APPENDIX B

Airport Noise Advisory, Technical and Citizen Advisory Committees Presentations and Responses to Input

B.1 PRESENTATIONS

ANAC Noise Recommendation 15 – Alt 1 Design

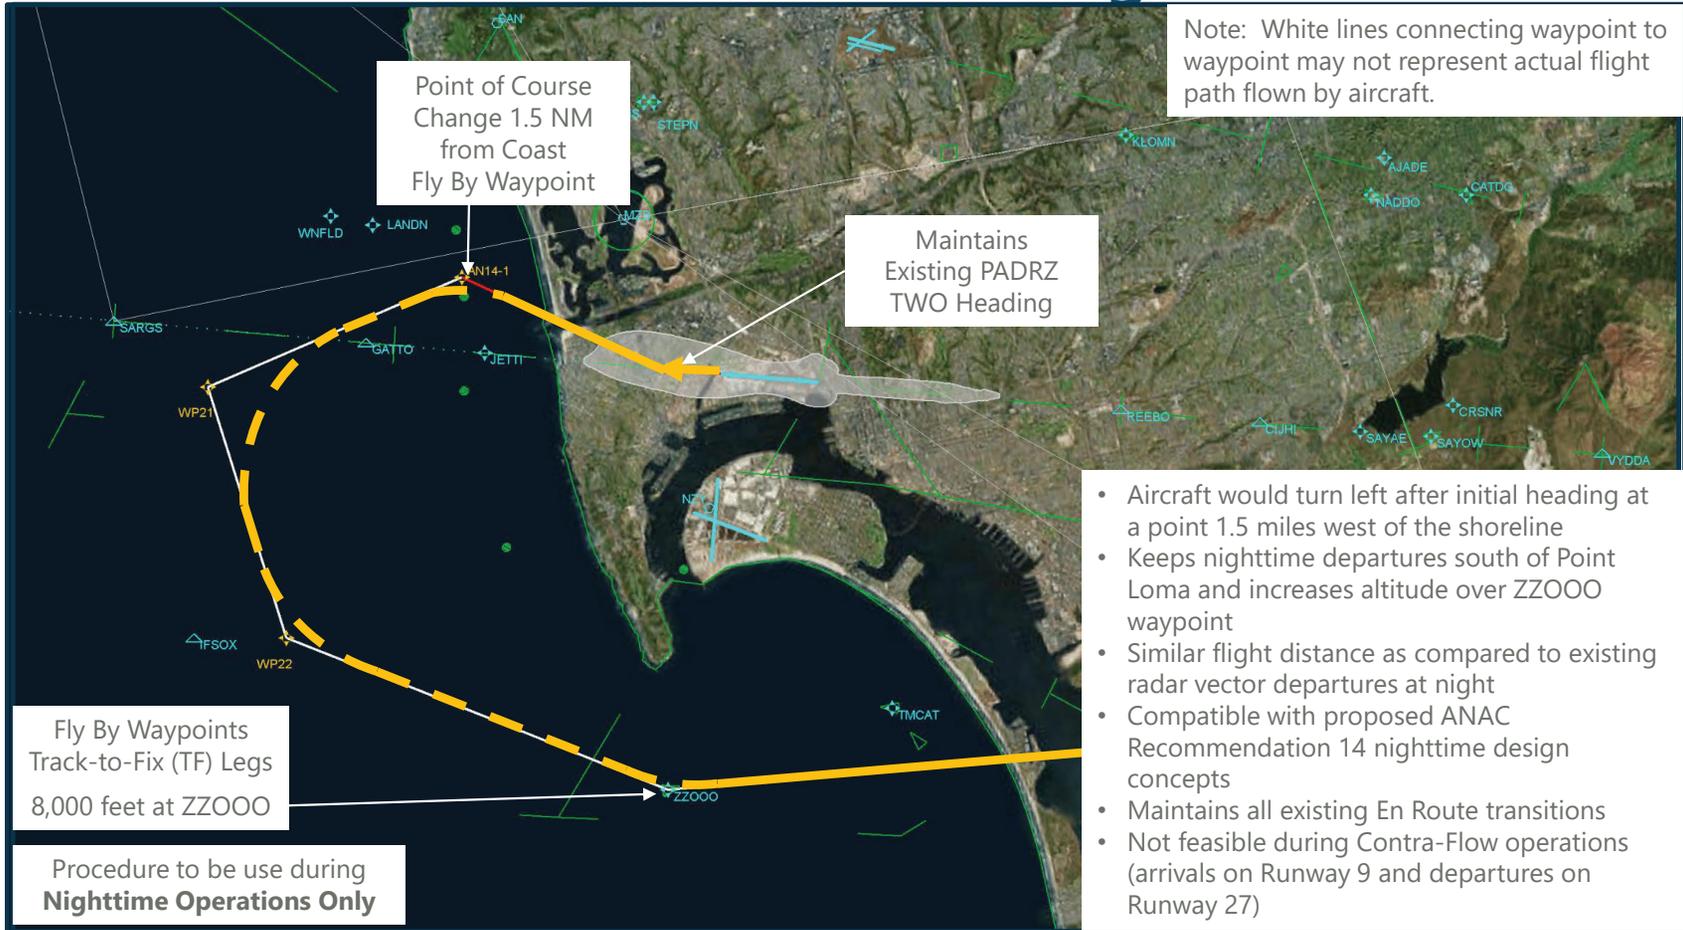
7/27/18	Casey Schnoor	Sunset Cliffs/Fleetridge	Rec. 15 - Alternative 1	C-18	JETTI extension from 1 to 2 miles offshore, while maintaining 230 kts speed restriction to increase altitude (for most aircraft) at ZZOOO is preferable, as long as it does not encourage ATC vectoring that eliminates ZZOOO, causing increased tracks between Red Noise Dots #4 and #5 and ZZOOO	Refer to response to Comment #C-1.
7/27/18	Casey Schnoor	Sunset Cliffs/Fleetridge	Rec. 14 - Nighttime Alternative - Initial Heading	C-19	Takeoff minimums should also be modified to preclude headings right of 290 degrees as is currently occurring after attaining 500-520' causing significant impacts to South Mission Beach, as our tracking data indicates; "275 to 520 feet" is not working to restrict tracks as high as 295 to 305 degrees	Refer to response to Comment #C-13.
7/27/18	Casey Schnoor	Sunset Cliffs/Fleetridge	Rec. 14 - Nighttime Alternative	C-20	WNFLD\LANDN should be moved to this 290 heading (satisfying 15-degree divergence) and become a "Fly Over" waypoint; JETTI has successfully managed left turns as a "Fly Over" so right turns should have the same restrictions	Refer to response to Comment #C-12 regarding feasibility of the initial heading from Runway 27. Recommendation 14 Alternatives for nighttime operations do not rely on LANDN and WNFLD waypoints. A new proposed waypoint south of LANDN and WNFLD would be used to direct aircraft in a westerly direction to stay south of La Jolla after passing the first fly-by waypoint (1.5 NM from the shoreline or a point between the shoreline and 1.5 NM out). Designating this turning point as fly-by best meets the intent of Recommendation 14. The design maintains the existing initial heading design in order to maintain existing overflight traffic patterns over areas exposed to CNEL 65 and higher. If a recommended initial right turn heading is proposed during the Part 150 Study update process, the final design may be modified to accommodate the heading.

DRAFT Deliberative Document – For Discussion Purposes Only
ANAC Noise Recommendation 16 – Alt 1

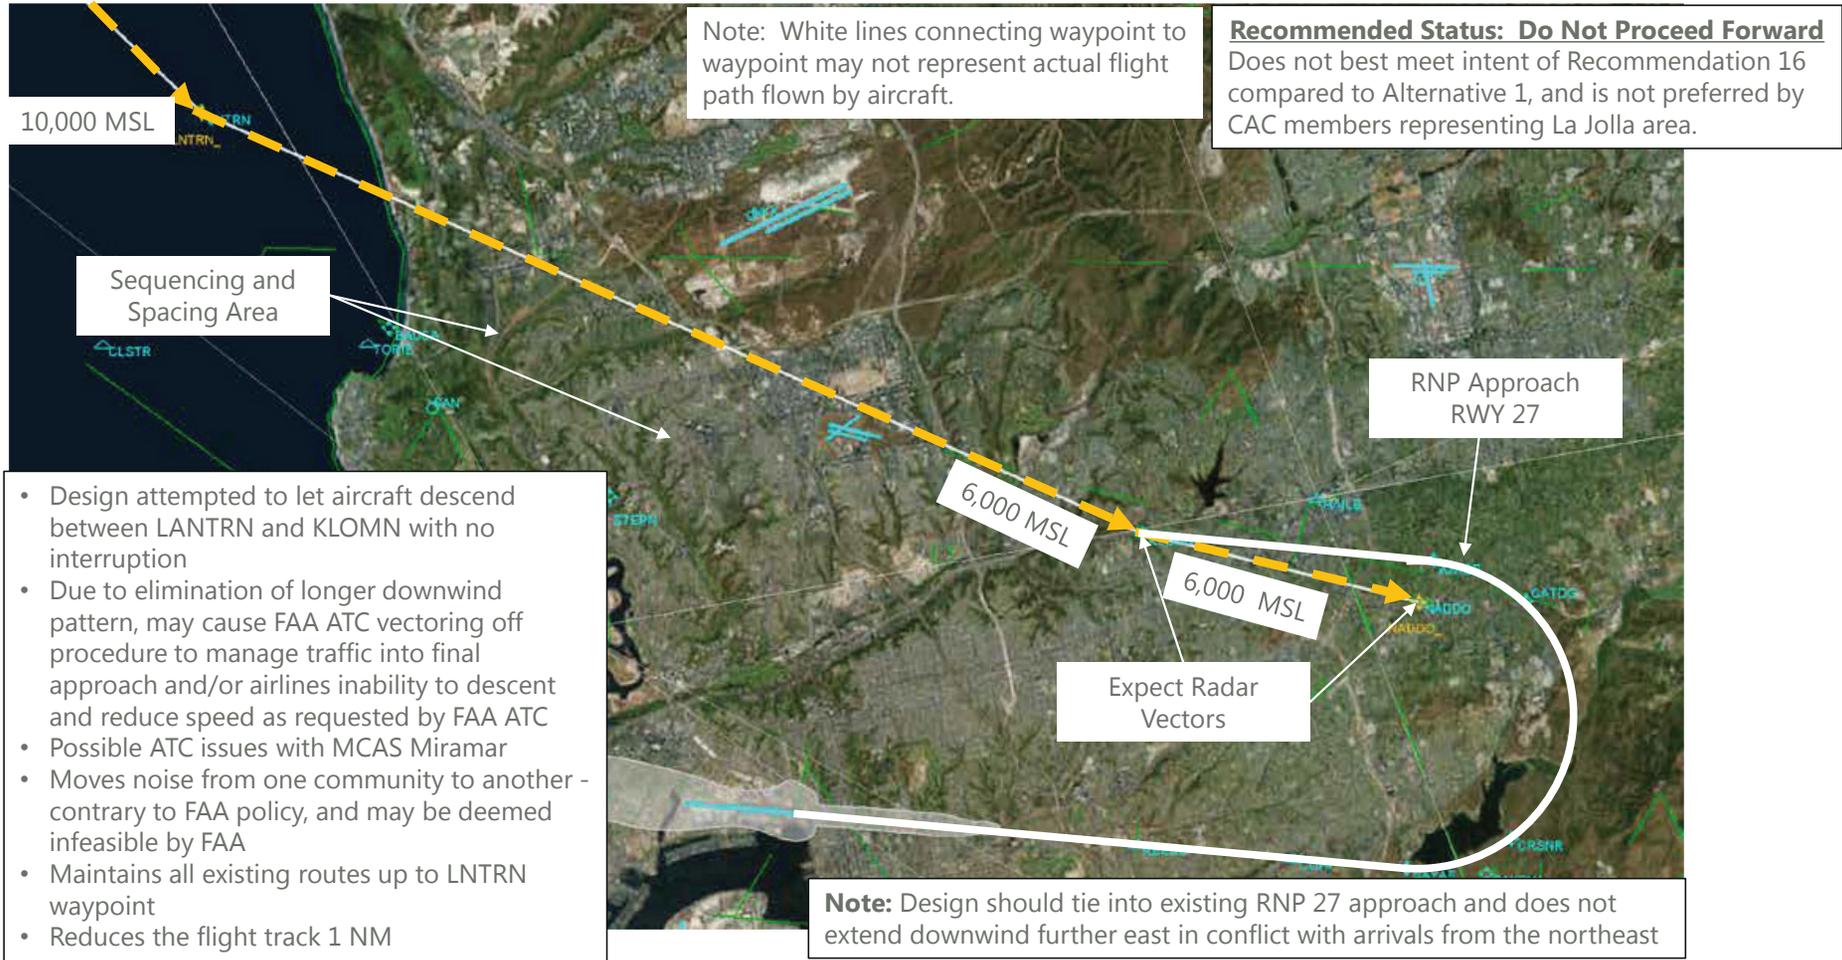
7/25/18	Anthony Stiegler	Muirlands/La Jolla	Rec. 16 - New Concept	C-7	Discussed the COMIX TWO (RNAV) Arrival way points, and my question and suggestion that flights be routed from COMIX directly to KLOMN, rather than through or via LNTRN. This would appear to cover less distance, be more fuel efficient and route arrivals over more unincorporated and undeveloped land, further away from La Jolla. I believe that route would be closer to the Miramar landfill and the I805/SR52 intersection without infringing on Miramar Air Station's airspace. Fellow CAC member Alan Harris discussed that flight arrival data from pre-2013 shows flights on this sort of path, substantially further north from La Jolla. The fact that this arrival path was used in the past suggests its viability. Please consider whether this alternative is feasible	Directing arrival traffic from the COMIX waypoint to KLOMN waypoint would shift traffic crossing the shoreline over the southern portion of the Torrey Pines Golf Course (Alternative 1 design) to over Del Mar residents. Moving arrival traffic closer to Torrey Pines Golf Course would likely be preferred over establishing a new route over a residential area. Additionally, TAC airline members expressed concerns about procedures, such as the COMIX STAR, that require aircraft to descend and to reduce speed at the same time. The TAC airline members are concerned that Recommendation 16, Alternative 1 would require additional measures during descent while reducing speed (e.g., use of speed brakes) in order to comply with the procedure. This procedure will especially challenge newer generation aircraft with modern wing lift capabilities. The shorter distance of the proposed concept from the COMIX waypoint compared to Recommendation 16, Alternative 1 would most likely exacerbate concerns related to descending and speed reduction, and therefore, would not likely be feasible. Historically, the FAA has changed procedures in this area over the years as RNAV technology became more prevalent. The first RNAV for arrivals from the northwest was the BAYVU STAR, which was amended five times after initial implementation. Prior to the BAYVU STAR, a conventional STAR based on ground-based navigation and radar vectors was in place. If the procedure defined as Recommendation 16, Alternative 1 is deemed feasible, the FAA will compare future operations under it to a "No Action" condition in the same year, as required under the National Environmental Policy Act (NEPA) by following FAA Order 1050.1F, <i>Environmental Impacts: Policies and Procedures</i> , to determine if the proposed procedure would be expected to cause significant environmental impacts and reportable changes. The consultant team expects to conduct the comparison using FAA's Aviation Environmental Design Tool (AEDT) model if a design concept is deemed feasible based on design parameters. The No Action condition would be defined by conditions that would be in place if the proposed change is not implemented. Therefore, when comparing the proposed procedure to the No Action condition, the No Action condition would be represented by existing traffic patterns rather than a range of historical traffic patterns/procedures. Because the justification for the proposed procedure would be to reduce community noise exposure, it is unlikely that FAA would approve a procedure that shifts noise exposure from one community to another based on the comparison between No Action (existing traffic patterns) and the Proposed Action (proposed procedure change).

7/25/18	Anthony Stiegler	Muirlands/La Jolla	Rec. 16 - LNTRN Altitude	C-8	If the COMIX to KLOMN flight path described above is not feasible, consider changing LNTRN to at or above 9,000' to better reflect the old BAYVU STAR profile over La Jolla.	Completed. The FAA modified the crossing altitude at the LNTRN waypoint from at or above 8,000 feet mean sea level (MSL) to at or above 9,000 feet MSL. This change is reflected in the COMIX 2 STAR procedure published May 28, 2018.
7/25/18	Anthony Stiegler	Muirlands/La Jolla	Rec. 16 - Alternative 3	C-9	As discussed during the July 19 meeting, La Jolla advocates for rejecting ANAC Noise Recommendation 16 Alternative 3 as a non-starter for La Jolla. The path would bring flights closer to La Jolla and increase the noise impact over La Jolla Shores and the Muirlands.	Recommendation 16, Alternatives 2 and 3 concepts have been removed from further evaluation.

DATE	NAME	REP.	CONCEPT	COMMENT #	COMMENT FROM CAC MEMBER	RESPONSE
7/25/18	Anthony Stiegler	Muirlands/La Jolla	Rec. 16 - Alternative 1	C-10	There is general public consensus that the "no shifting noise" policy is being unfairly applied in San Diego. Measuring flight noise as of the current date, rather than considering the conditions existing prior to implementation of NextGen Metroplex, misses the mark. The FAA changed flight paths by implementing Next Gen but did not reject those changes because they moved noise onto previously unaffected communities, like La Jolla. It is now paradoxical to refuse to make remedial changes because they would shift noise back to the areas previously impacted prior to the NextGen Metroplex implementation.	Under the SoCal Metroplex, the COMIX STAR flight track was shifted 1,200 feet south over the La Jolla area but the altitude as aircraft crossed the shoreline was increased. In a study conducted by BridgeNet International, (https://bit.ly/2DhDD6i starting on Page 22) it was determined that the "...changes were not in themselves sufficient to result in measurable changes in noise." Furthermore, analysis of 18 years of historic data (the SDCRAA's Airport Noise and Operations Monitoring System [ANOMS]) shows that, historically, aircraft were dispersed over the La Jolla neighborhoods. When the FAA implemented the first RNAV (satellite-based) procedure (BAYVU 1), the flight corridor became increasingly concentrated. The images below show 2 days of San Diego International Airport (SDIA) arrivals by year. Refer to response for Comment #C-7 regarding noise comparison analysis to determine potential impact.
